## TECHNICAL ANALYSIS

Tank Seam Road  
Co-Op Mining Company  
Bear Canyon Mine  
ACT/015/025

July 20, 1994

## Simplified Bishop Slope Stability Analysis

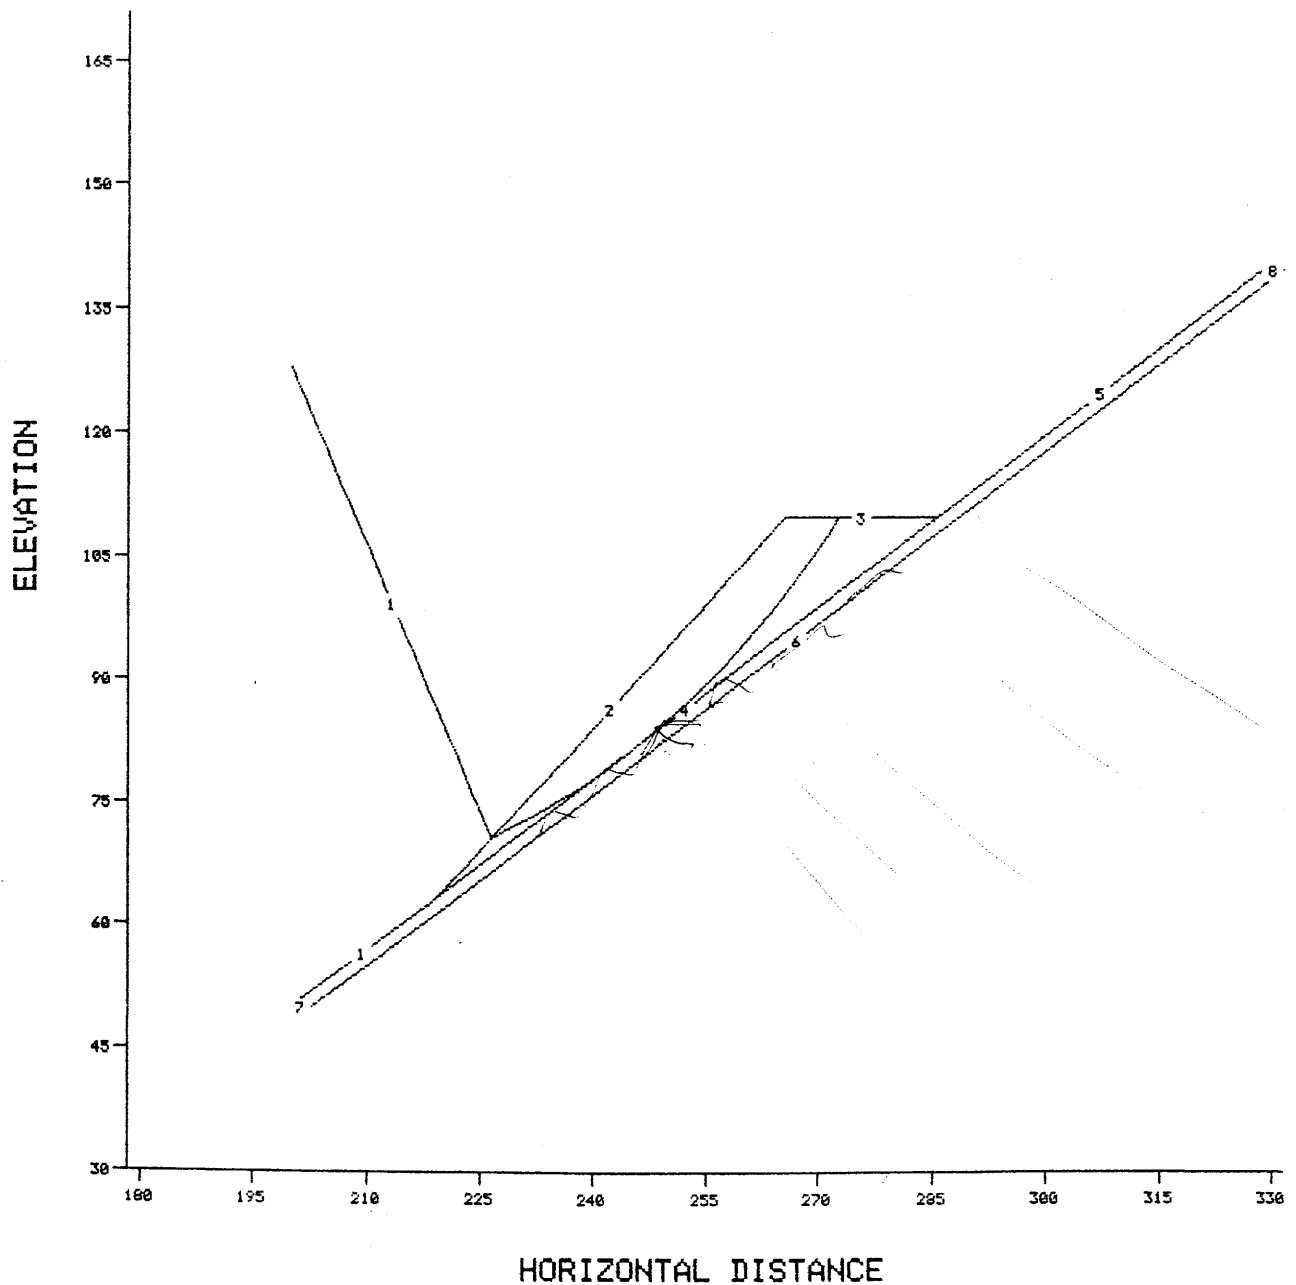
**Fill Slope:** The Division did not agree with the initial Dames and Moore study regarding the fill-slope. Even after the Division added a strong bedrock layer 6 feet under the natural soil the safety factor continued to be 1.1.

When Dames and Moore learned of the low safety factor they revised their assumptions about the slope's profile. They claimed that if the slope was modeled with bedrock steps then the safety factors would be satisfactory. Dames and Moore did not supply the Division with any information on the steps spacing or demonstrate that the steps would prevent failure.

When the Division analyzed the slope using Dames and Moore revised assumptions the safety factor was 1.31. When saturated soil conditions were assumed the safety factor dropped to 1.29. The regulations require road embankments to have safety factors no less than 1.3.

The bedrock step spacing is important. The Division has demonstrated that if a 40 gap in the bedrock can result in a safety factor of 1.2.????????? While Dames and Moore's assumption about steps may appear reasonable they have supplied the Division with no information that such conditions will occur on all fill surfaces.
